**RECOMMENDATION MEETING**

**9218 18th Ave SW  
Seattle, WA 98106**

3036383-LU  
3036384-LU  
3036524-EG

8.0 ITEMIZED RESPONSE TO EDG 2

FIG 1 - DEVELOPED PREFERRED OPTION

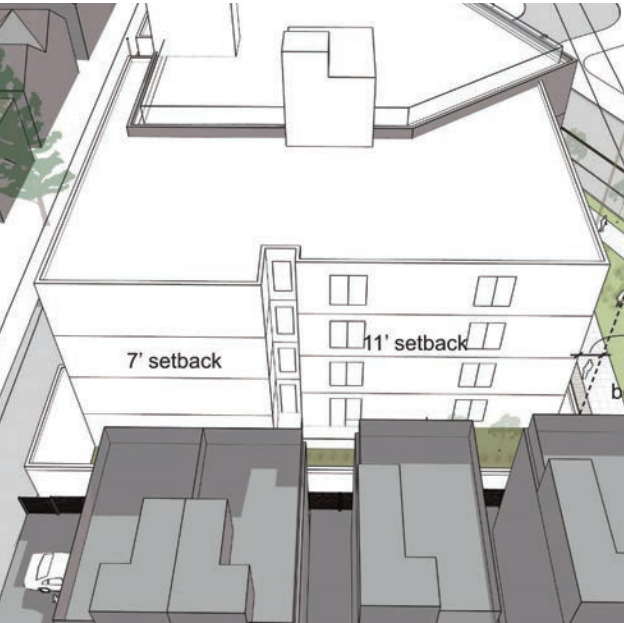
The Board appreciated the way in which the applicant articulated the 2 massing elements and how each related to Delridge Way SW and 18th Avenue respectively. The Board recommended that this be retained moving forward. (CS1-B-2, CS2-B-2, CS2-C-1)

The Board applauded the applicant for providing large setbacks at the west half of the north and south sides of the building, however, they were particularly concerned about the large expanses of blank wall proposed on the eastern portions of the north and south facades. The Board directed the applicant to integrate more glazing into these facades, specifically at the east ends towards the alley, and on the west facing return walls, to reduce the impacts associated with the blank walls and to improve solar access for residents. (CS1-B-2, DC2-B-2)

The 2 massing elements shown at EDG 2 have been incorporated into the design. They have been reinforced by their differing materiality and fenestration treatment, signifying a difference in street character. See Fig 1.

The eastern portion of the south façade has been pulled back from the property line to allow for glazing and glazing has been added to the west facing return walls. Additional glazing has also been provided at the north façade. Windows and vegetation have been carefully considered to provide air and light for new residents and privacy for the residents to the north. See Fig 2 & 3.

FIG 4 - LANDSCAPE DESIGN AT GROUND LEVEL

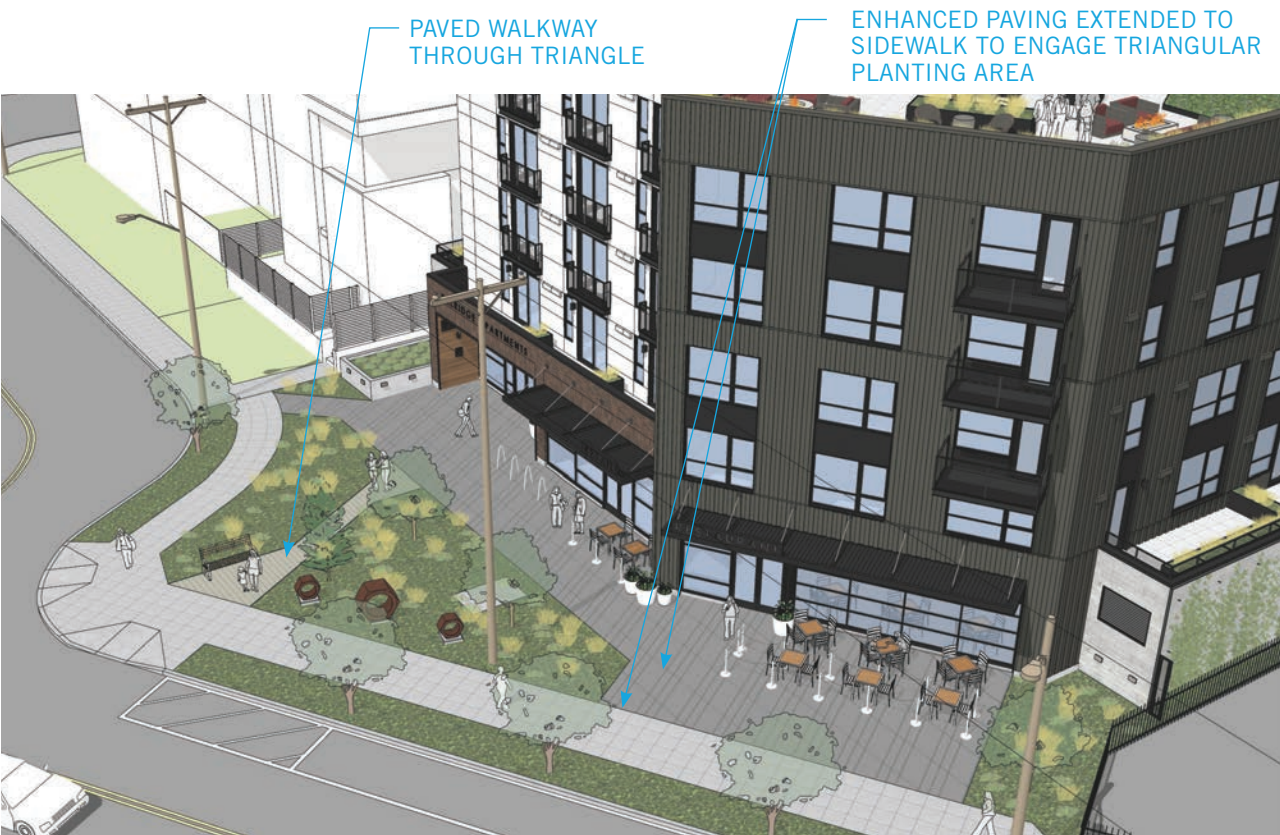
The Board appreciated the amount of pedestrian connectivity and the streetscape experience and the increased opportunities for activity to spill out into the public right-of-way to create a more active and engaging public realm. The Board recommended that the applicant work with SDOT to incorporate the large triangular right-of-way planting strip into the overall landscape design. (PL1-B-3, PL3-C)

The Board noted that the strong massing of Option 5 with its two distinct volumes, successfully addressed the EDG guidance related to the ability to divide the one large commercial space into two identifiable smaller spaces. The Board recommended that the applicant study how the design of the storefront and hardscape might further enhance the delineation between to two spaces. (CS2-B-2, PL1-A-1, PL1-A-2, PL2-A-1)

The project is continuing coordination with SDOT landscaping in the ROW as part of the SIP process. The landscape planting materials and species on site will be similar and consistent to those located within the ROW. The enhanced paving pattern and color within the property line has been extended into the ROW to engage the triangular planting area. A paved walkway has been extended through the triangle to provide a direct walking route between the building and Delridge Way SW and provide better visual access to the sculptures installed by SDOT. See Fig 4.

Variation in material, orientation, and the way the materials meet the ground provide visual delineation between the two masses and differentiate two smaller commercial spaces. To unify the look and feel of the open space at ground level and avoid visual busyness, the concrete pattern at both commercial entries and the residential entry are continuous. The differentiation between the 2 commercial spaces are emphasized by the difference in material and orientation toward the street, as well as additional planters to divide the space. See Fig 4 and 5.

CODE COMPLIANT REDESIGN

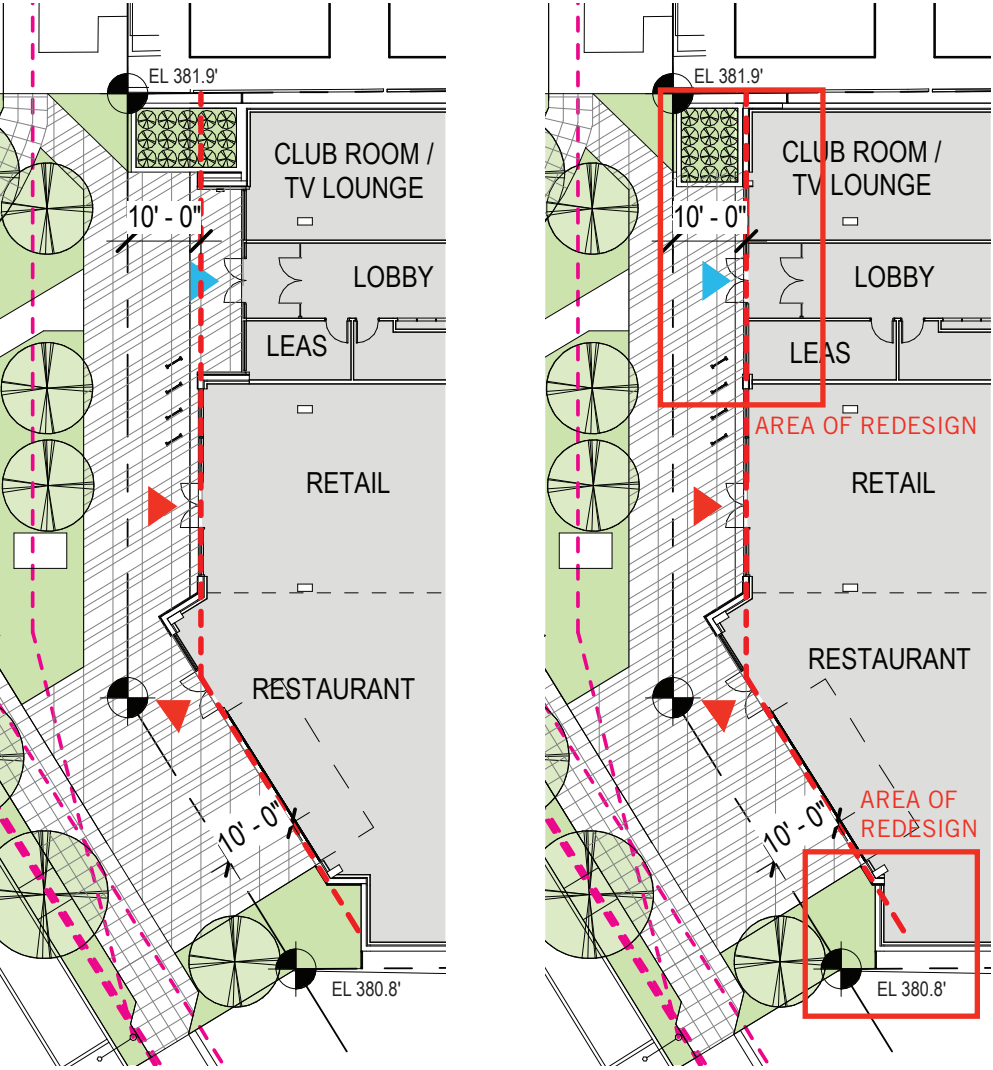
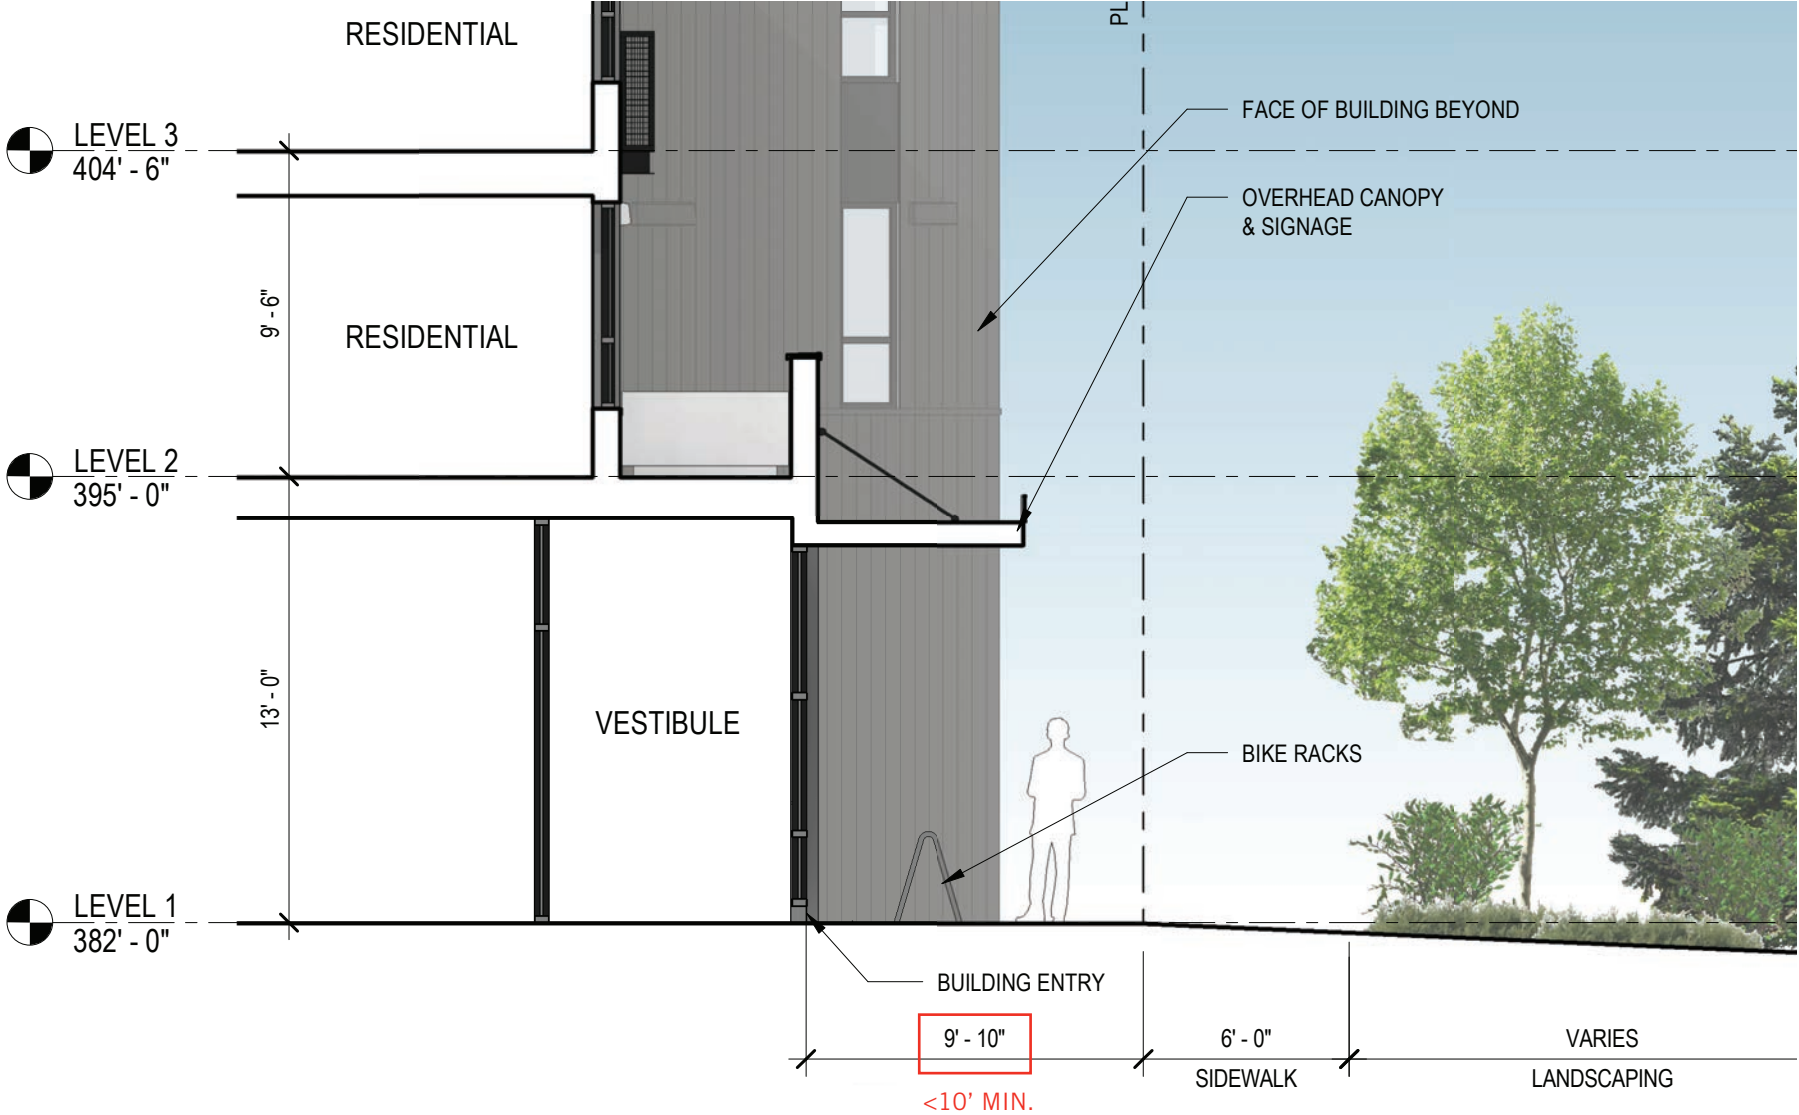
CODE CITATION:	23.47A.008.A.3
CODE REQUIREMENT:	Street-level, street-facing facades shall be located within 10 feet of the street lot line, unless wider sidewalks, plazas, or other approved landscaped or open spaces are provided.
CODE COMPLIANCE:	Portions of the facade at 18th Ave SW (Residential Entry) and Delridge Way SW (southwest corner) need to move within 10' of the lot line in order to be in compliance with code.

CODE CITATION:	23.47A.008.A.3
CODE REQUIREMENT:	Street-level, street-facing facades shall be located within 10 feet of the street lot line, unless wider sidewalks, plazas, or other approved landscaped or open spaces are provided.
CODE COMPLIANCE:	Portions of the facade at 18th Ave SW (Residential Entry) and Delridge Way SW (southwest corner) need to move within 10' of the lot line in order to be in compliance with code.
